**GARY
MATZNER
PARK**

FOUNTAIN PIPING PLAN

REVISIONS		
NO.	DESCRIPTION	DATE
	ISSUED FOR BUILDING PERMIT	11/21/24
	REVISED FOR BUILDING PERMIT	01/10/25
1	BLDG PERMIT REV. 1	04/28/25
2	RFI #5	11/03/25
3	RFI #22 RESPONSE	12-15-25

NO.	DESCRIPTION	DATE
	ISSUED FOR BUILDING PERMIT	11/21/2024
	REVISED FOR BUILDING PERMIT	01/10/2025
△	BLDG PERMIT REV. 1	03/28/2025
1	RESPONSE TO RFI-22	12/15/2025

SITE DETAILS

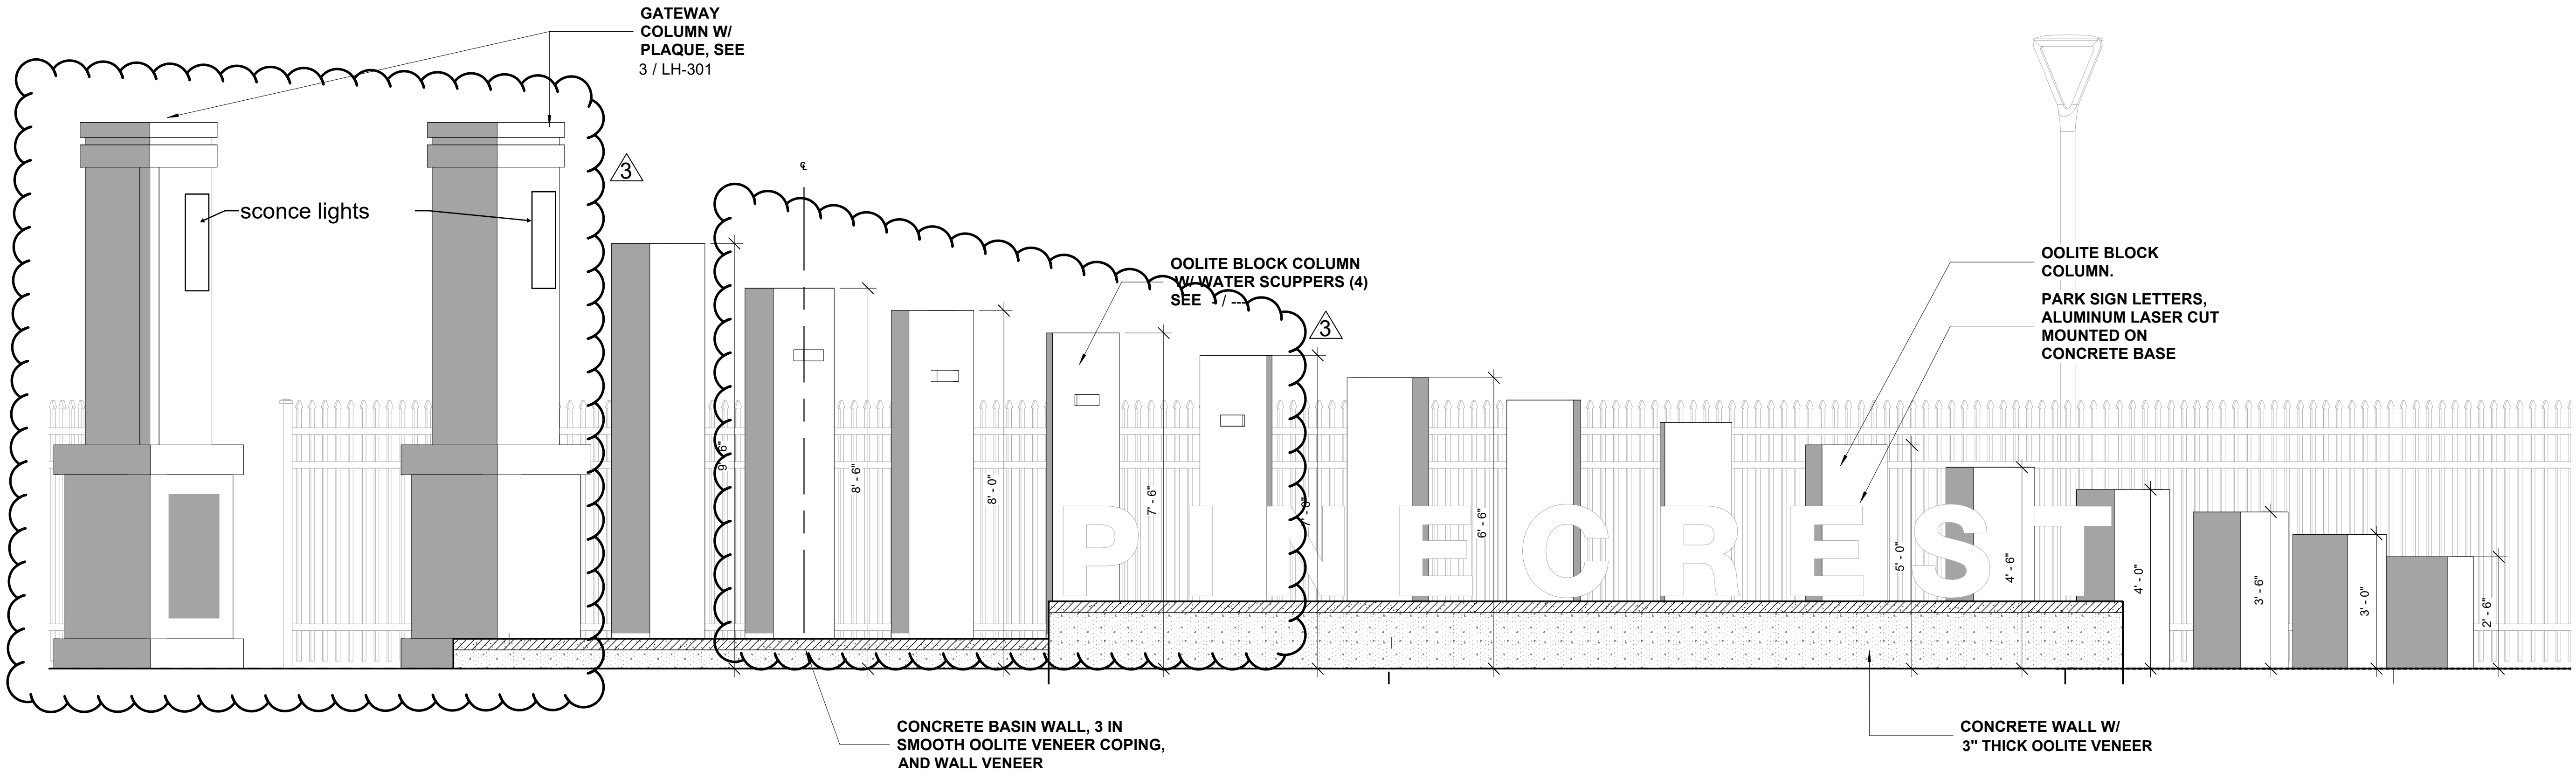
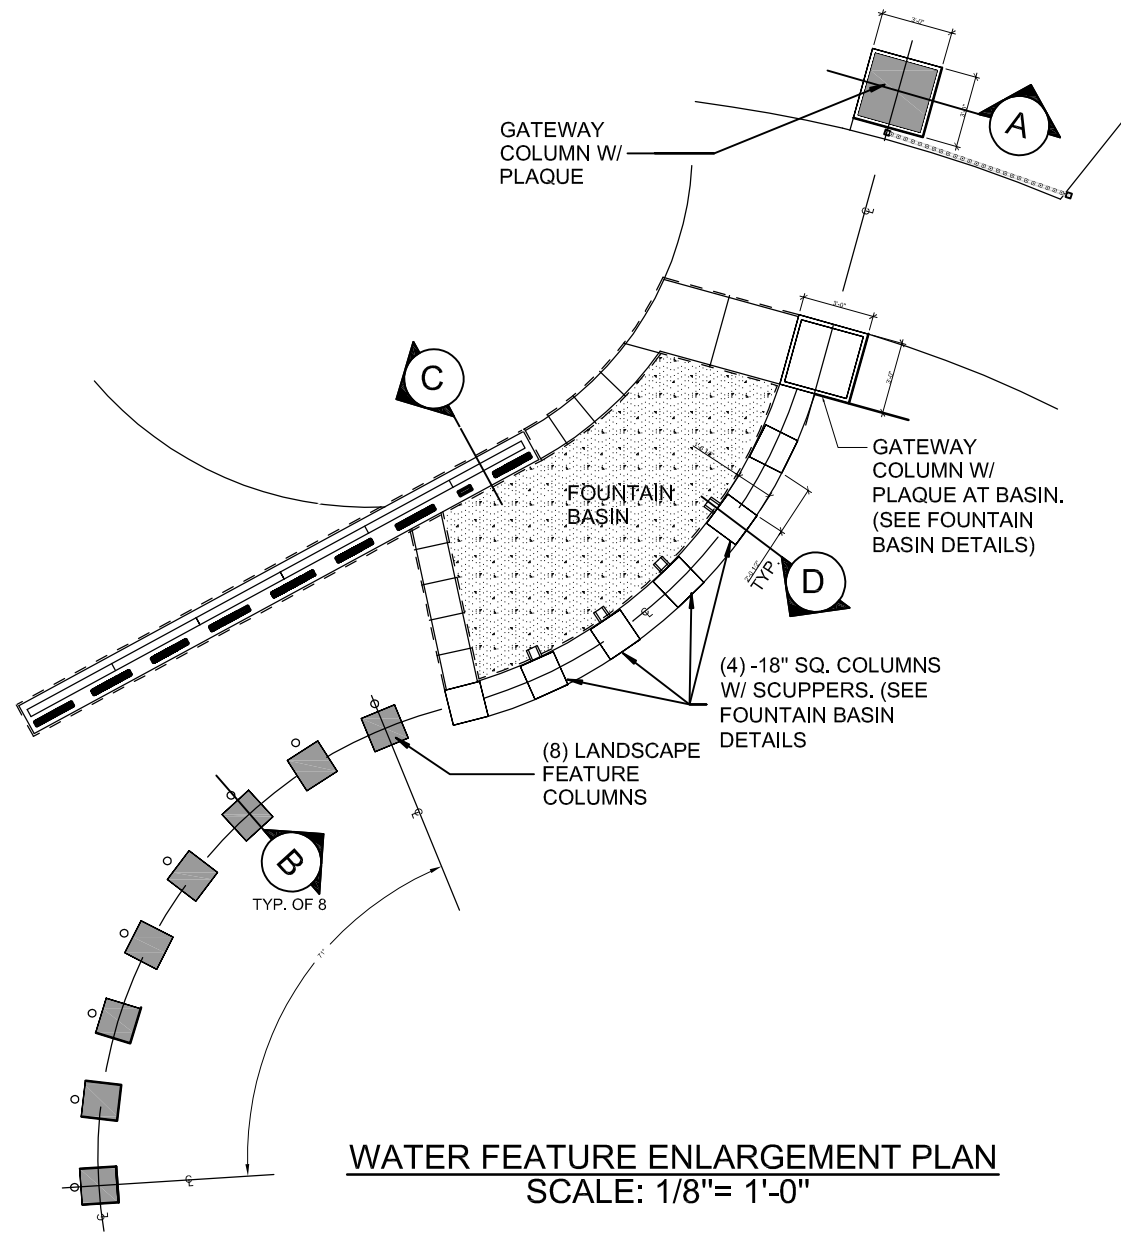
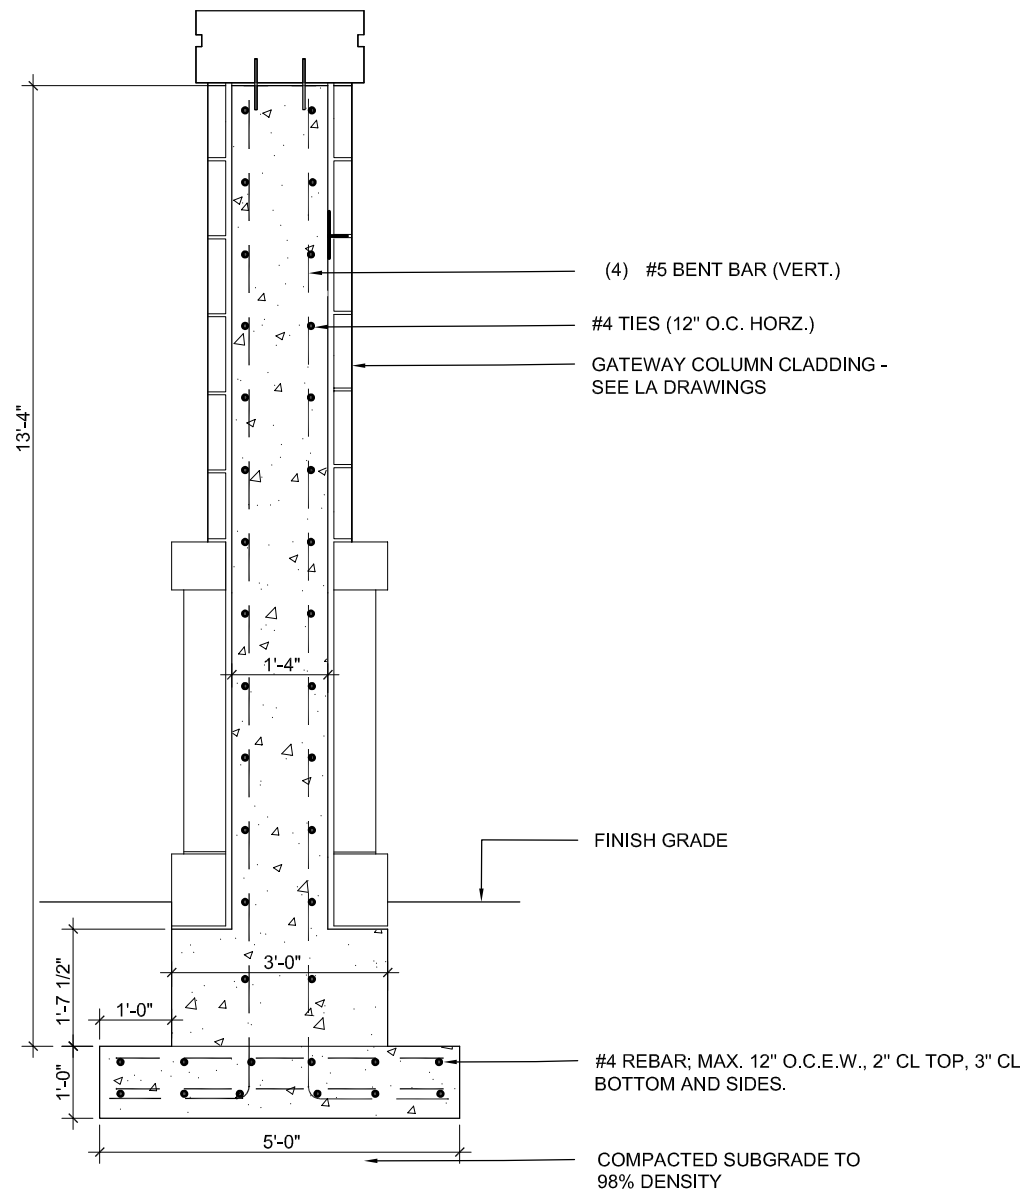
FOR REFERENCE ONLY.
(ORIGINALLY SUBMITTED
FOR RFI-05)
